LARAMIE COUNTY PLANNING & DEVELOPMENT DEPARTMENT

TITLE: PUBLIC HEARING regarding a Subdivision Permit & Plat for Meadowlark Airpark, located at Govt. Lots 1, 2, 3, and 4 less a portion, and all of the NW1/4 SE1/4 less a portion, Sec. 6, T.14N., R.64W., of the 6th P.M., Laramie County, WY.

PZ-20-00330

RE: Meadowlark Airpark Final Plat Traffic & Drainage Study Waiver Request

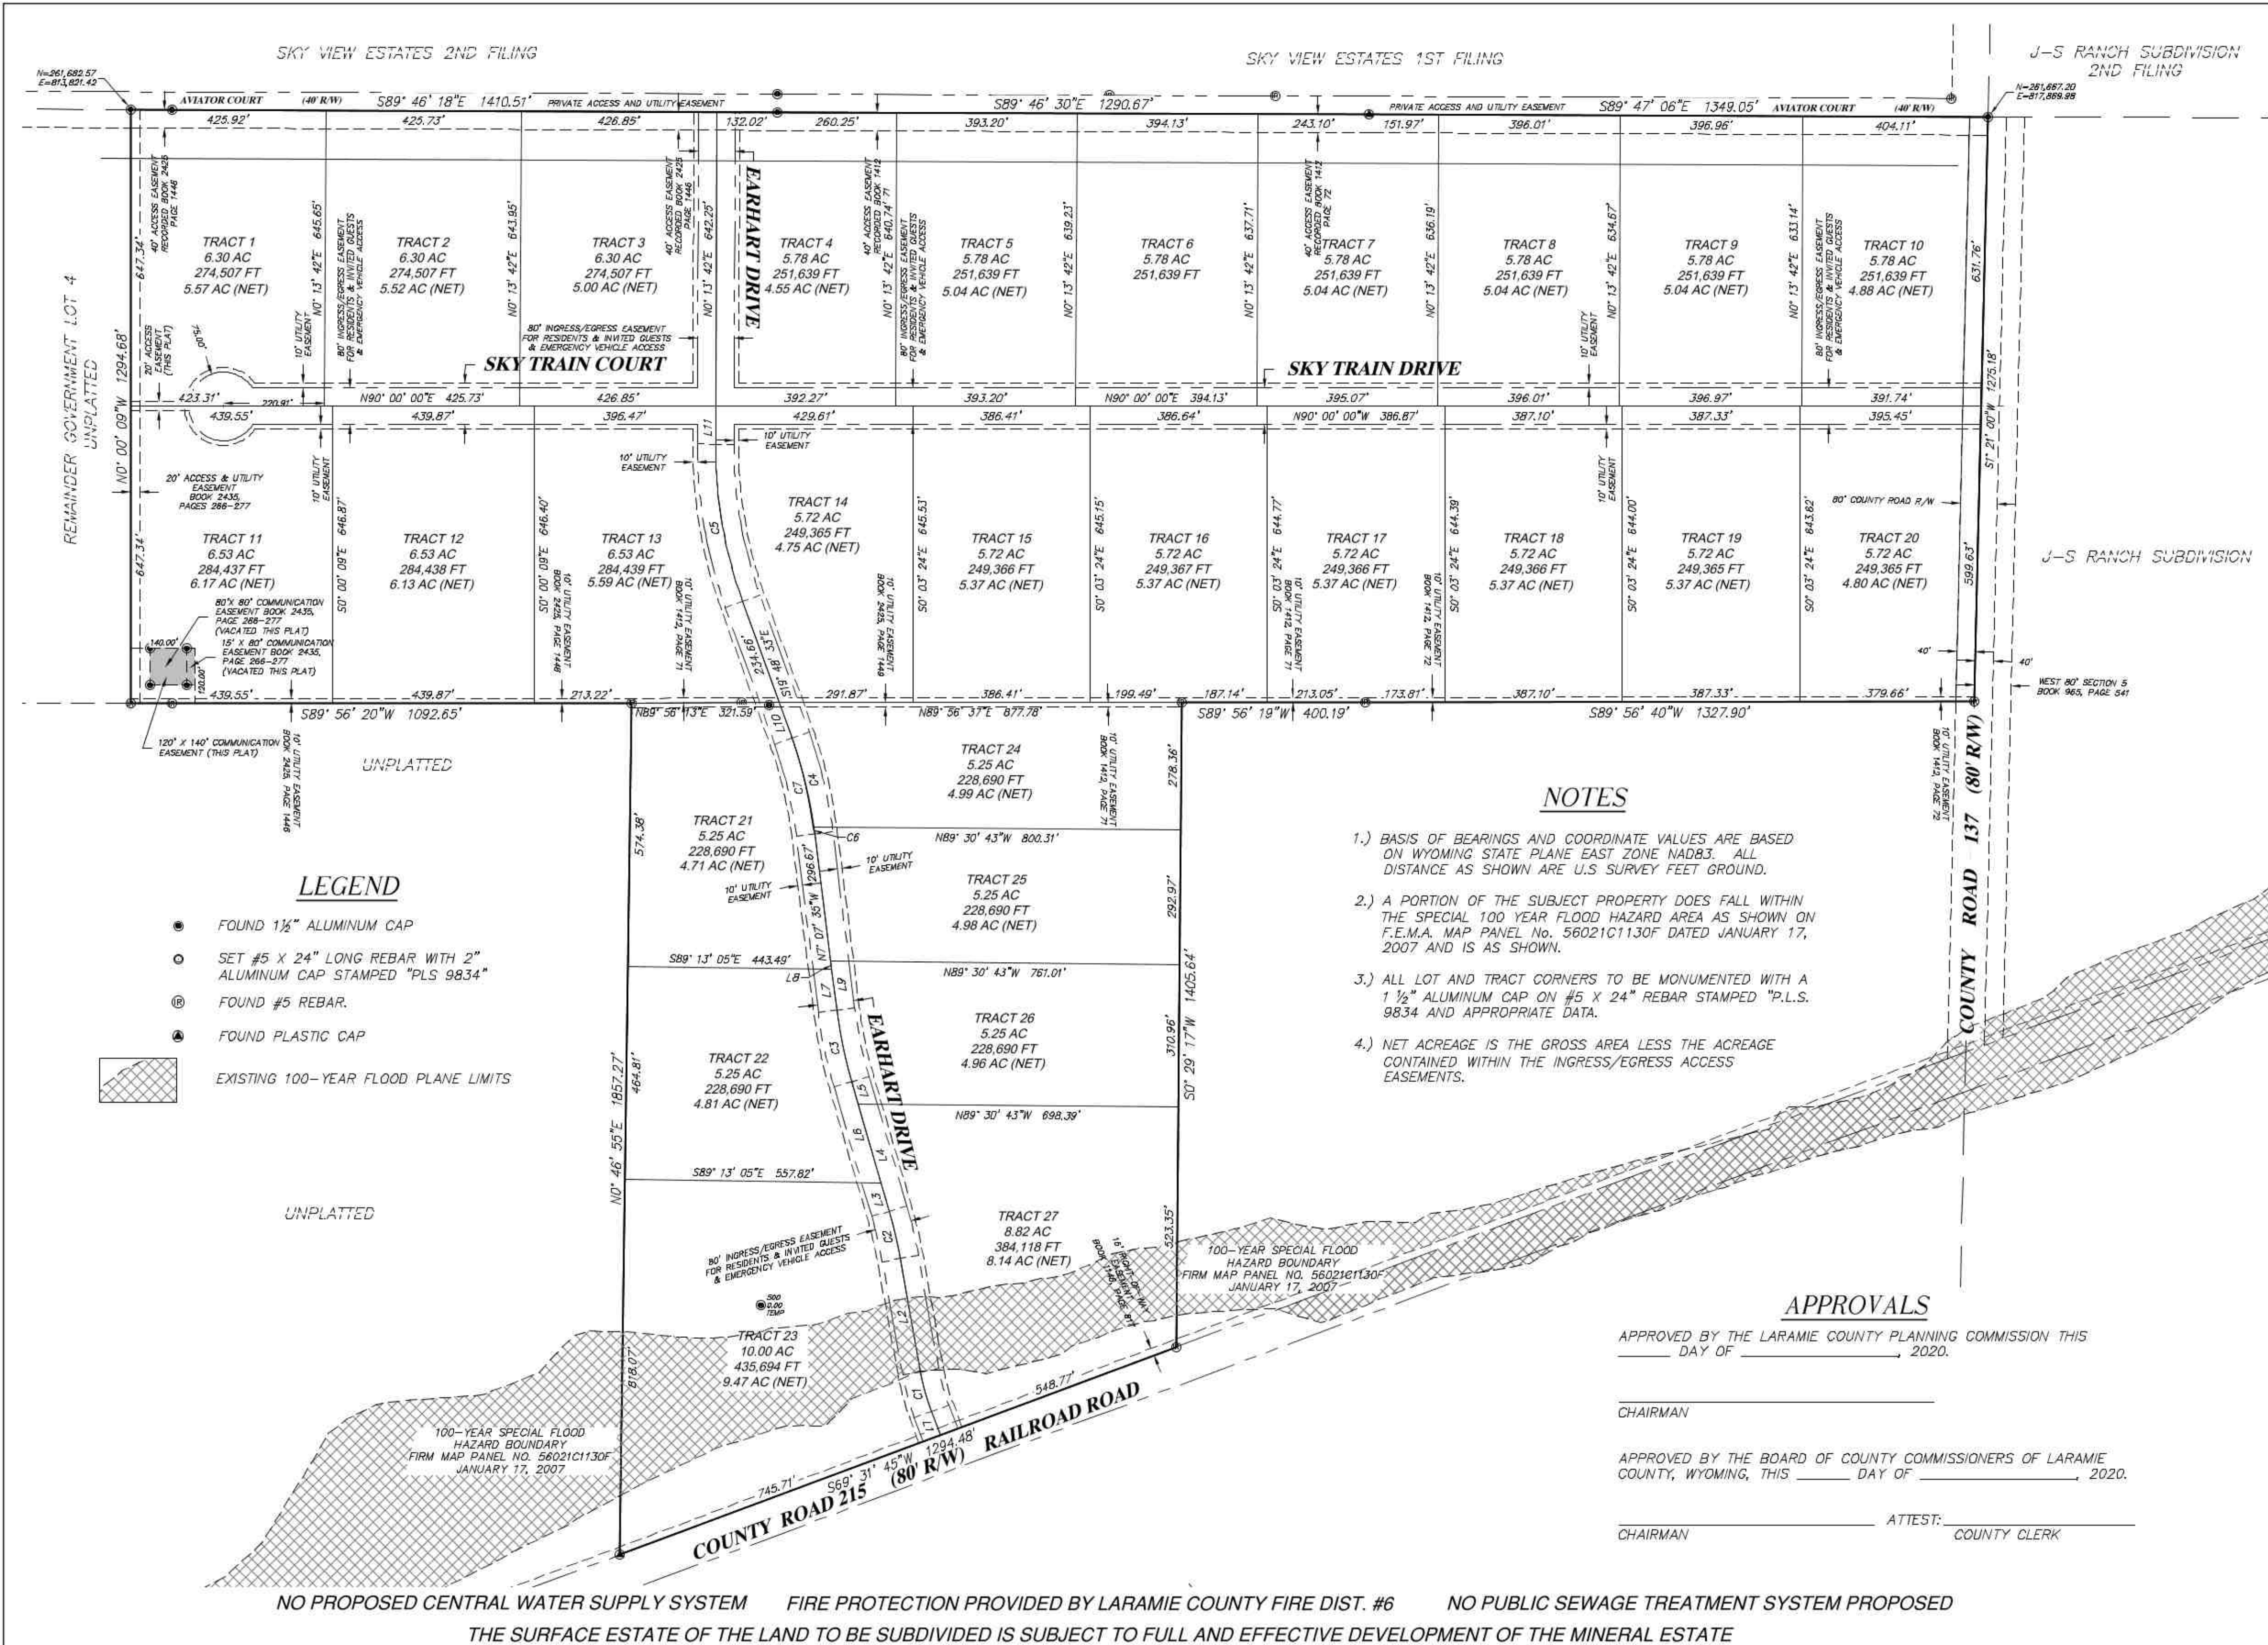
County Assessor: County Assessor, Kaycee Eisele Comments Attached 12/28/2020
In the title block, Airpark is one word, which is what our records will reflect but in the dedication it is 2 words.

4. The Curve Table on the plat does not show the information for C6 and C7 that are called out on the drawing.
5. The Line Table on the plat does not show the information for L10 and L11 that are called out on the drawing.

6. The dates on the plat for approvals show 2020 and these should be changed to 2021.

1. In the first line of the last paragraph of the DEDICATION "HAS" should be "HAVE", in the second line of the same paragraph "THERE" should be "THEIR" and in the third line of the same paragraph "THERE" should be "THEIR".

2. The dimension arrow indicating the north boundary of SKY TRAIN COURT, shown along the south boundary of TRACT 2, is drawn/connected to the north boundary of the 10' UTILITY EASEMENT, not to the north boundary of SKY TRAIN COURT.
3. Along the east boundary of TRACT 4, the text identifying the 40' ACCESS EASEMENT is overlapping the dimension of the east boundary of TRACT 4.
4. What is the purpose/function of the "WEST 80' SECTION 5-BOOK 955, PAGE 541" labeled east of the southeast corner of TRACT 20?

1. In the first and fourth paragraphs of the dedication, the subdivision is referred to as "Meadowlark Air Park", but in the title is is referred to "Meadowlark Airpark". Please revise.
2. The third paragraph of the dedication should also be updated to say "Said parcels" not "Said parcel".
3. The approval blocks must be placed directly next to the right or bottom border of the plat.
4. Approval Dates in the signature blocks must be updated to read 2021 rather than

5. Please label the property directly to the east of proposed tracts 24-27 as unplatted for continuity purposes.

6. Please add a note stated that the proposed roads will be privately maintained and will not be maintained by Laramie County.

7. Please update the Curve and Line Tables to show all Curve #'s and Line #'s as some are missing.

8. The acknowledgments signatures block will be signed in 2021, please update year.
